CITY OF ALBUQUERQUE

RE: **Lot 25 Block 8 Unit 5 SAD 227**
6201 Marigold Ct. NW
Volcano Cliffs Subdivision
Grading and Drainage Plan
Engineers Stamp Date 3/31/2023 (E10D124)

DRAINAGE AND TRANSPORTATION INFORMATION SHEET (REV 6/2018)

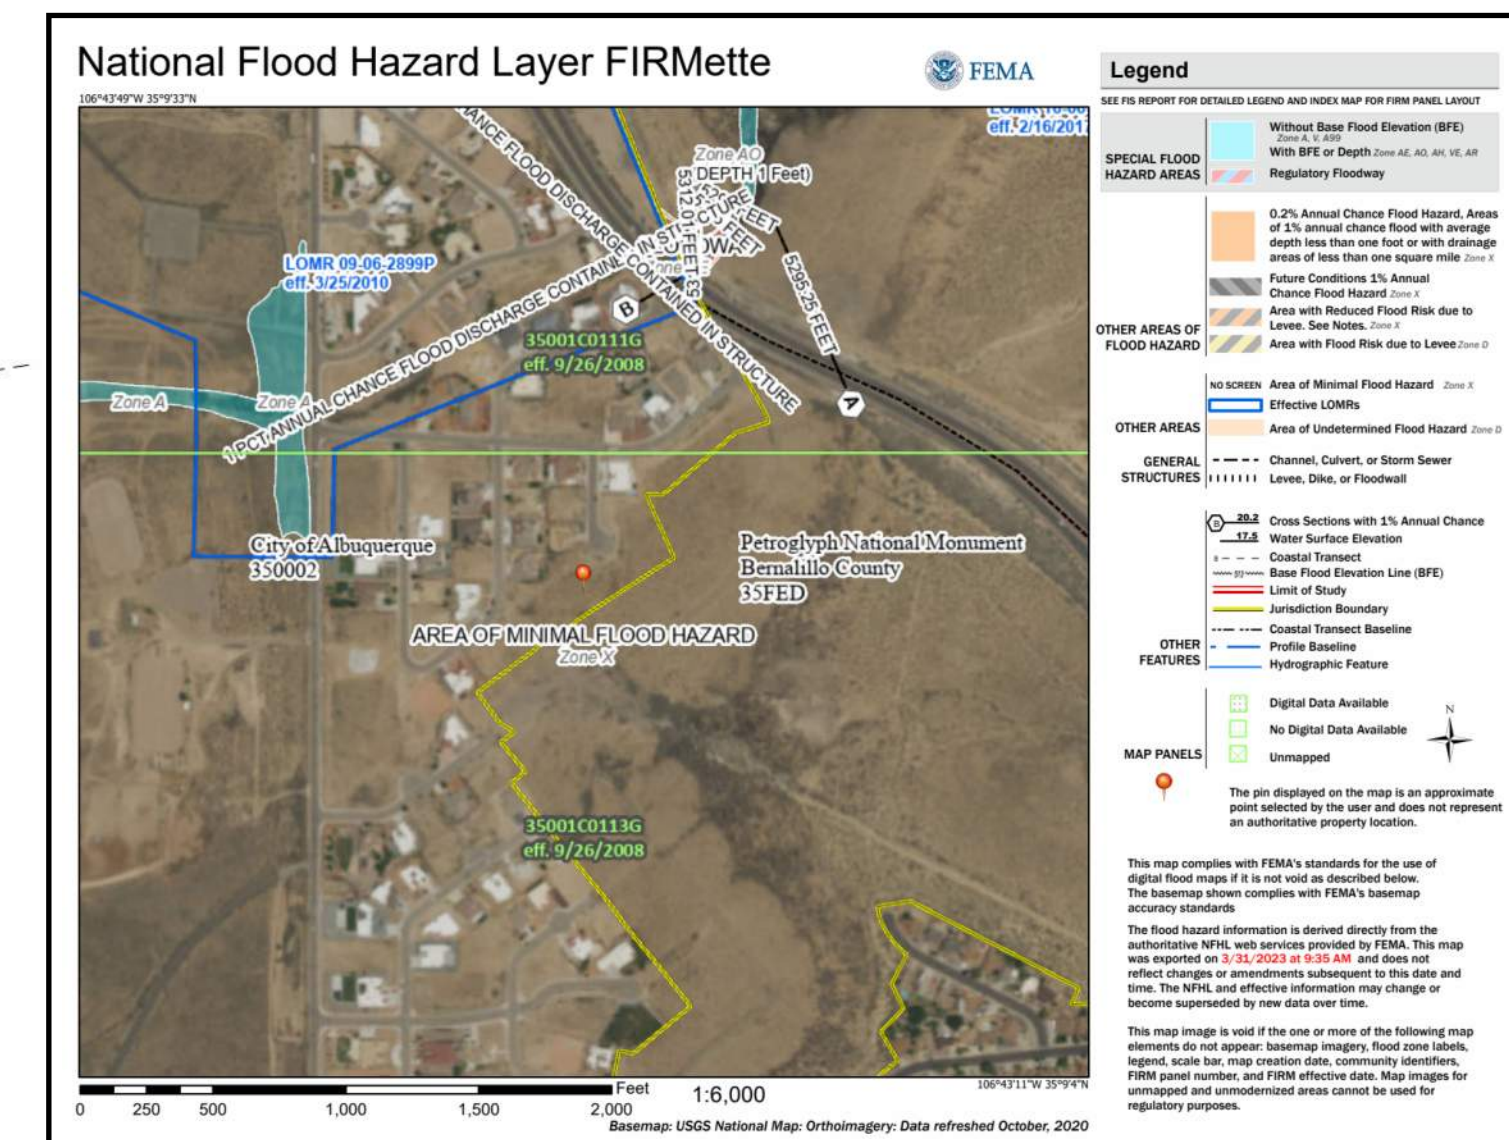
Advise the owner contractor not to use dirt as a ramp to climb the curb, use lumber or crusher fines for this purpose. Place this note on the plan.

Reiterate to the Owner/Contractor that a separate permit for a garden/retaining wall must be obtained with the approved G&D plan and Pad Certification. **Also, if a swimming pool is to be placed after this approval a new grading and drainage plan will need to be resubmitted showing the changes for the land treatments.**
